SUBJECT PROJECT: **GARDEN GROVE PARK IMPROVEMENTS-PHASE 2**  
**CITY PROJECT NO. 2163101280-2**

## ADDENDUM No. 3

IFB No. City Project 2163101280-2 Garden Grove Park Improvements - Phase 2

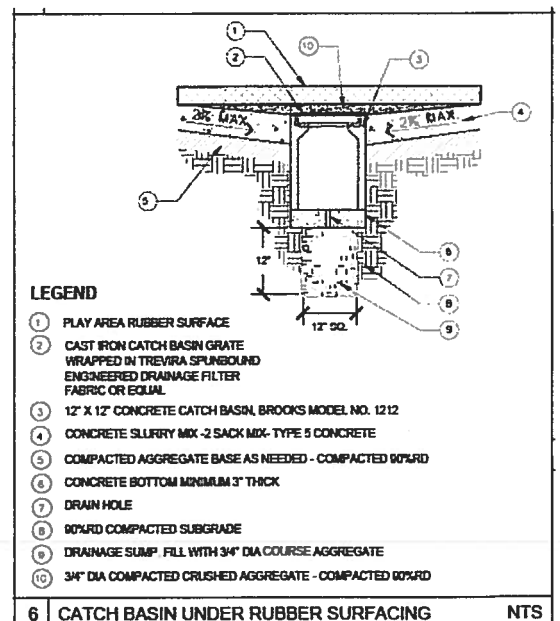
Keynote 8 on sheet L-1 is calling out "Catch Basin Under Surfacing". However on the layout, there was no Keynote 8 indicated. We need the location/s and quantity of these catch basins. Also, there is no bid item allocated for these catch basin unless you want this cost included on bid item 7 - Resilient Play Surfacing. Please clarify.

Please provide the actual color blend(s) for the playground safety surfacing Design – L-1 just states 100% Color.

There is to be one Catch Basin for each playground sub-area (generally centered within each space); so a total of two catch basins. The costs for the development of the catch basins is to be inclusive in the bid amount for Bid Item #7: Resilient Play Surfacing & Slurry Base.

Play Surfacing colors shall be standard colors, to include:

White/Crème/Eggshell  
Light Grey  
Standard Green
